NEBRASKA ARMY NATIONAL GUARD SIDNEY RC INTERIOR SUSTAINMENT

Sidney Readiness Center
2225 Legion Park Road
Sidney, NE 69162

PROJECT NO. 31030399

A D D E N D U M N O . 2

DRAWING TITLE:
 MAIN FLOOR PLAN - POWER
 SHEET #:
E202

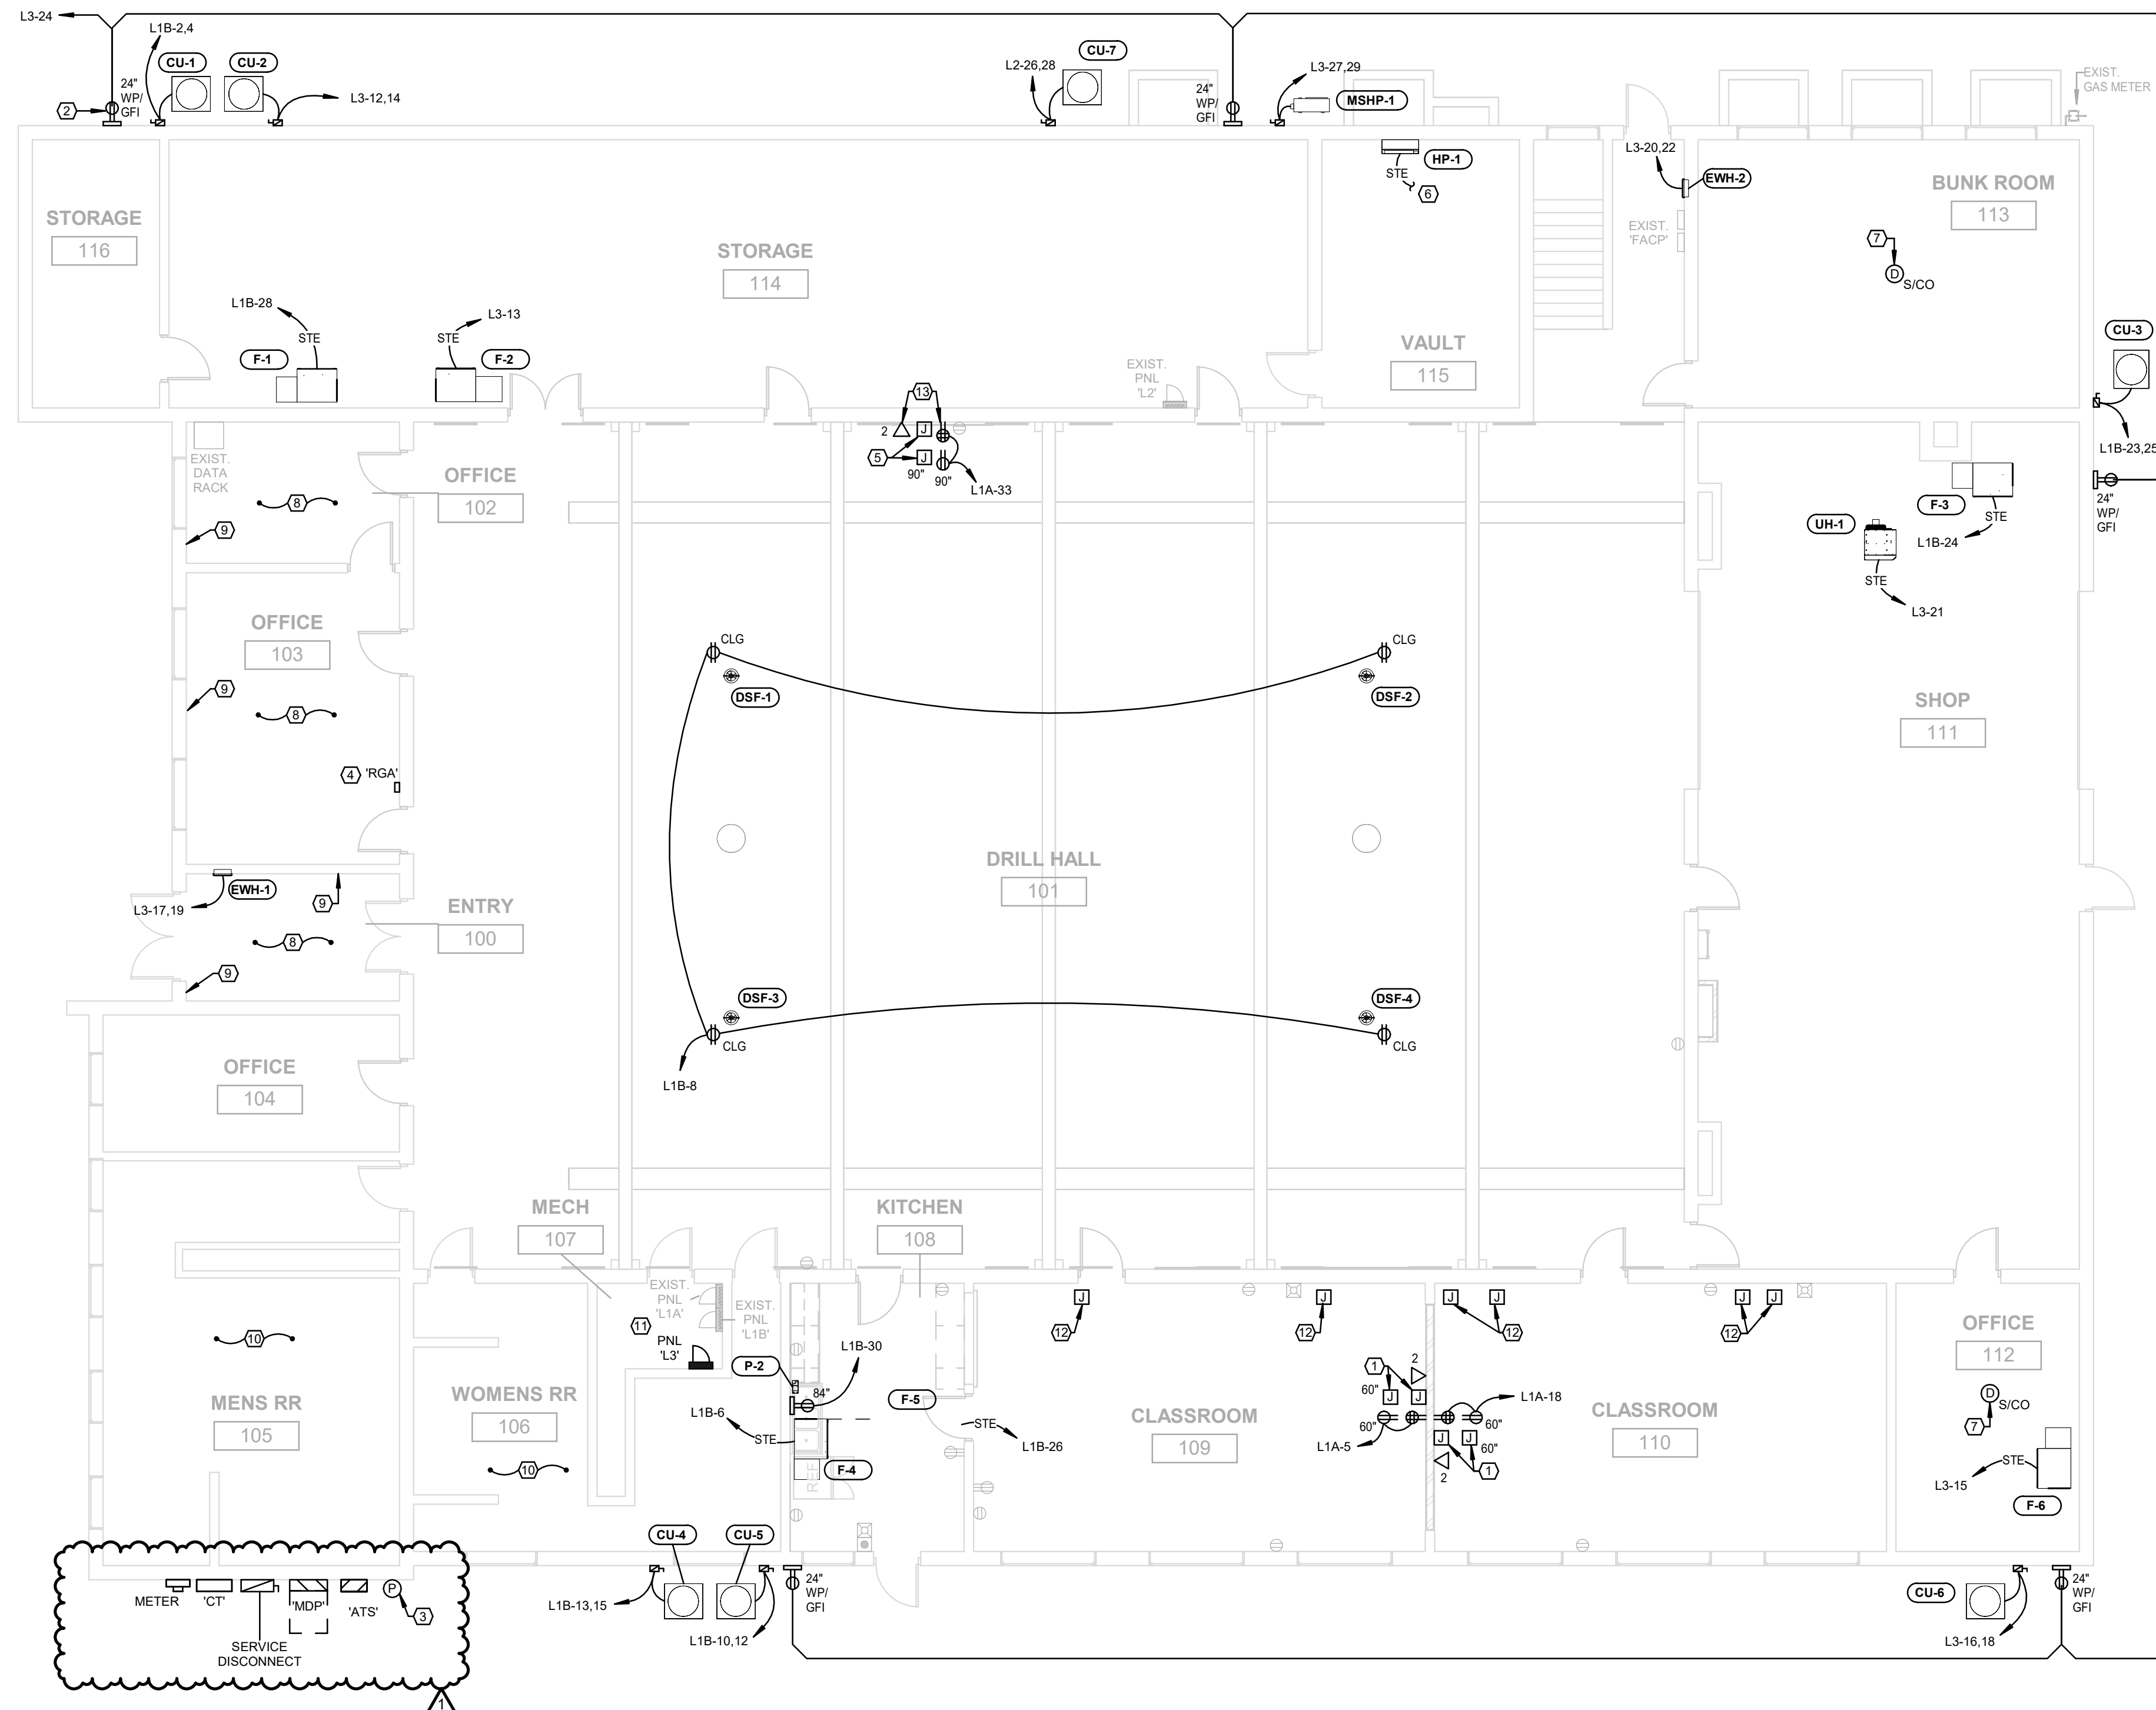
Sheet E202 - Main Floor Plan - Power

1. Added MDP at service entrance location on exterior of building.

DRAWING TITLE: ELECTRICAL SCHEDULE & RISER DIAGRAMS
SHEET #:
E401

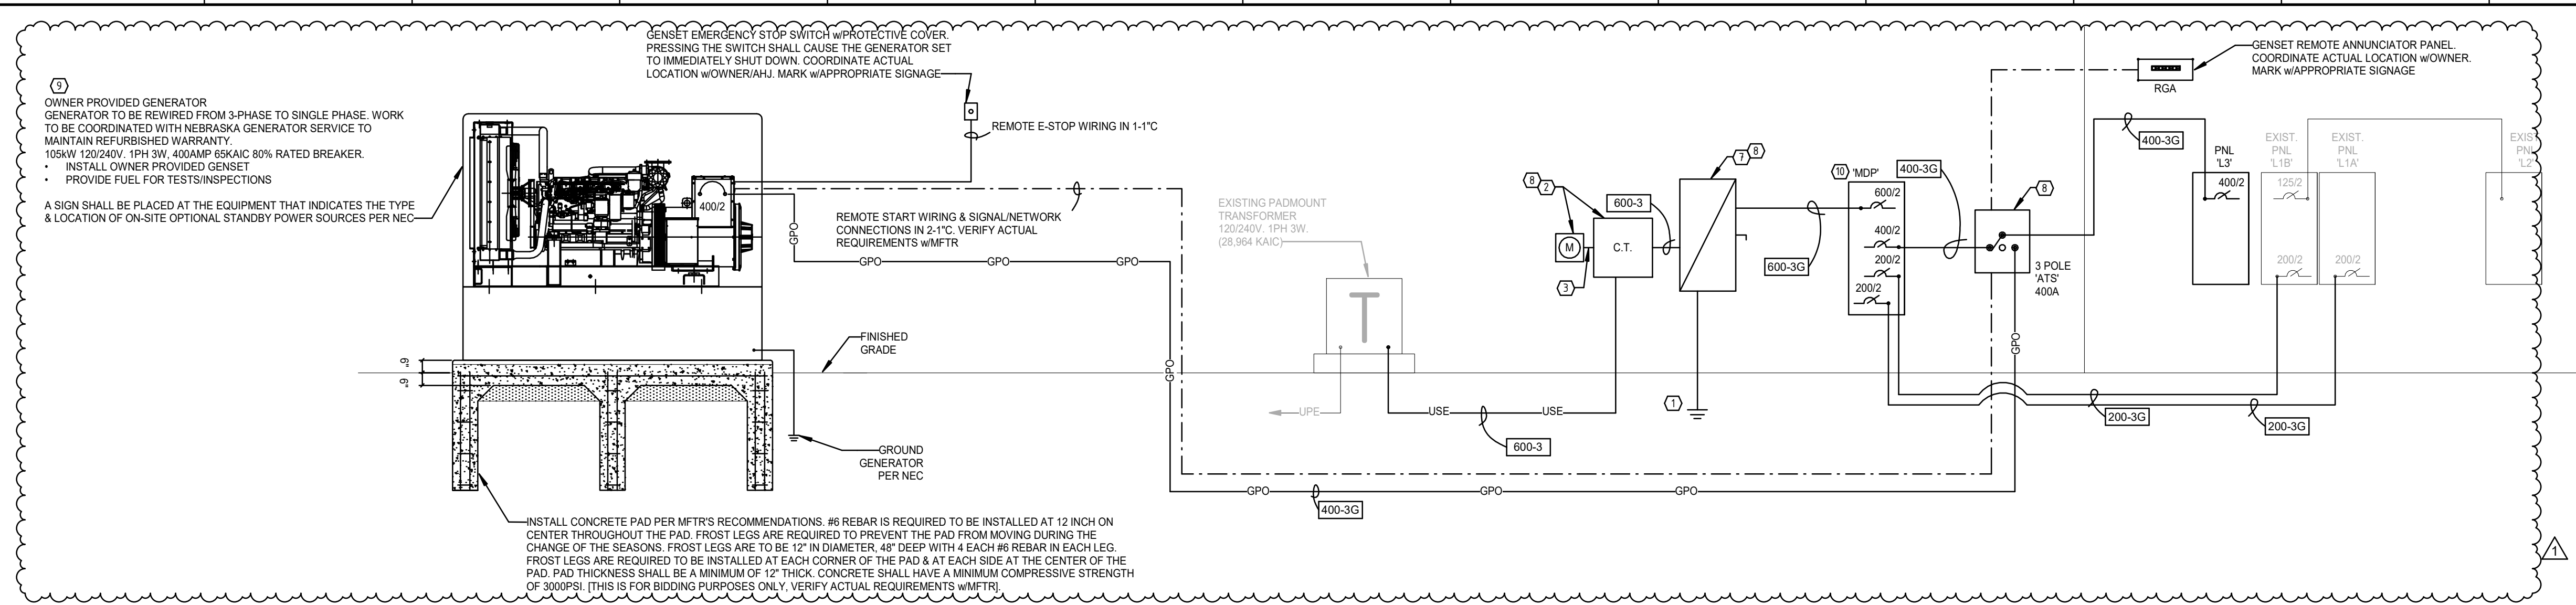
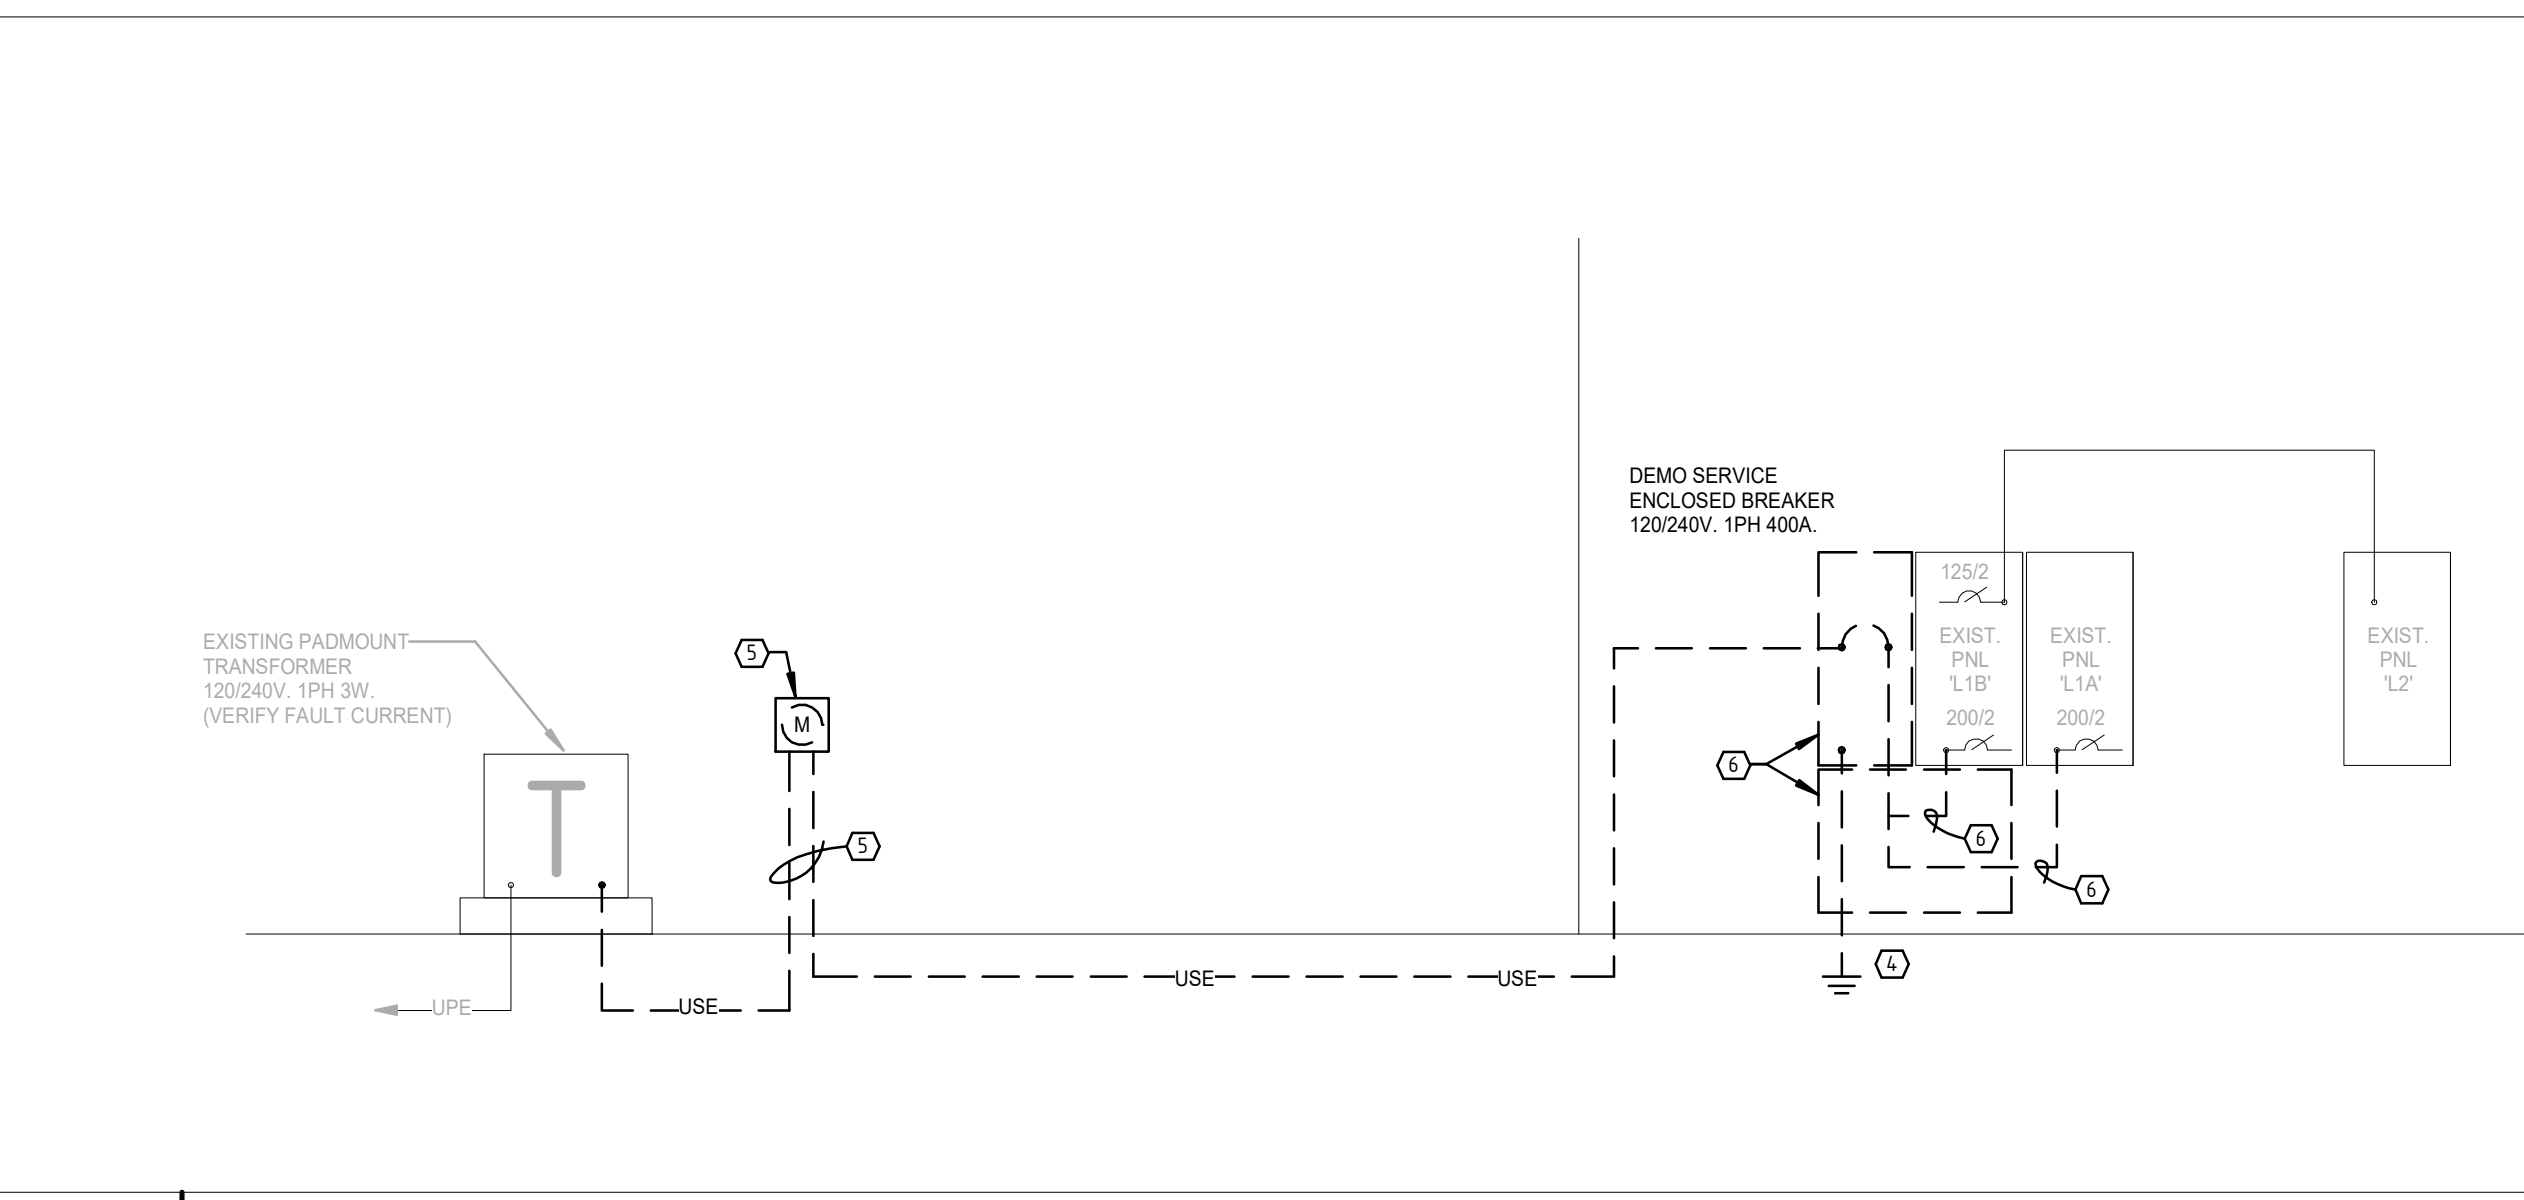
Sheet E401 – Electrical Schedule & Riser Diagrams

1. Added equipment connection schedule to sheet.
2. Added Keynote 9 to read: "GENSET IS BEING REFURBISHED BY OWNER. CONTRACTOR TO CHANGE FROM 3 PHASE TO 1 PHASE. COORDINATE WORK WITH NEBRASKA GENERATOR SERVICE, LLC. TO MAINTAIN WARRANTY."
3. Added Keynote 10 to read: "PROVIDE 600A, 120/240V I-LINE PANEL WITH LOCKABLE NEMA 3R ENCLOSURE AND BREAKERS AS SHOWN. SEE E301 FOR DETAILS."
4. Added Keynote 9 to Generator notes.
5. Added MDP to riser diagram and all changes that are required for the new service design.
6. Added Keynote 10 to MDP.
